Project	IEEE 802.16 Broadband Wireless Access Working Group < http://ieee802.org/16 >	
Title	R-MAC PDU format	
Date Submitted	2006-11-06	
Source(s)	<p>Hang Zhang, Peiyong Zhu, Wen Tong, Gamini Senarath, Derek Yu, Mark Naden, G.Q. Wang, David Steer,</p> <p>Nortel 3500 Carling Avenue Ottawa, Ontario K2H 8E9</p> <p>Kanchei (Ken) Loa, Yung-Ting Lee, Youn-Tai Lee, Heng-Iang Hsu</p> <p>Institute for Information Industry 8F, No. 218, Sec. 2, Dunhua S. Rd., Taipei City 106, Taiwan, ROC</p>	<p>Voice: +1 613 7631315 [mailto:WenTong@nortel.com]</p> <p>[mailto:pyzhu@nortel.com]</p> <p>loa@nmi.iii.org.tw</p>
Re:	A response to a Call for Technical Proposal, http://wirelessman.org/relay/docs/80216j-06_027.pdf	
Abstract	In this contribution, we propose a R-MAC header format upon which detailed R-MAC proposal can be used.	
Purpose	To incorporate the proposed text into the P802.16j Baseline Document (IEEE 802.16j-06/026)

R-MAC PDU Format

Figure 20m.

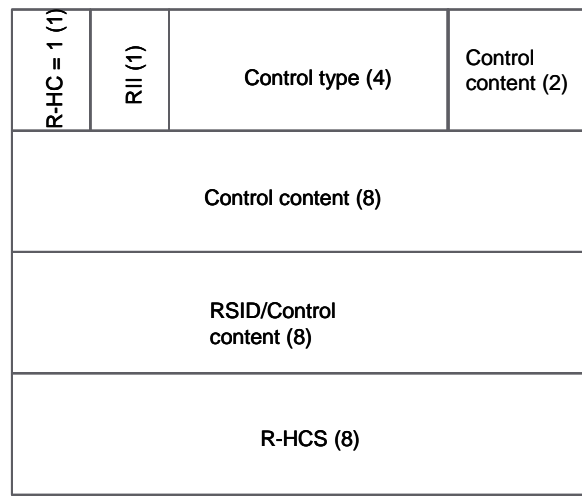
The format of type 1 R-MAC header is shown in Figure 20m.

The fields of type 1 R-MAC header are described in Table 7k.

Figure 20n.

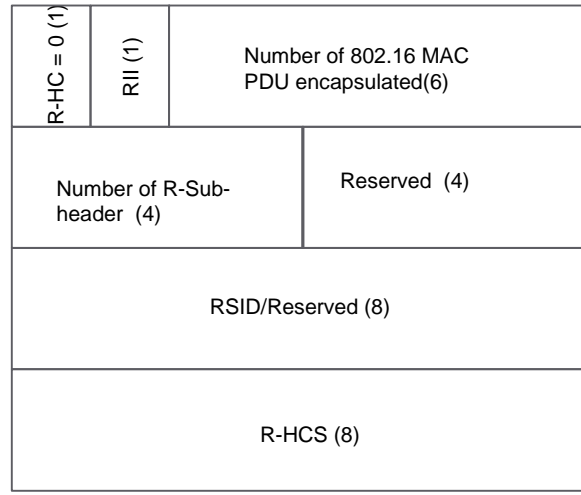
The format of type 2 R-MAC header is shown in Figure 20n.

The fields of type 2 R-MAC header are described in Table 7l.
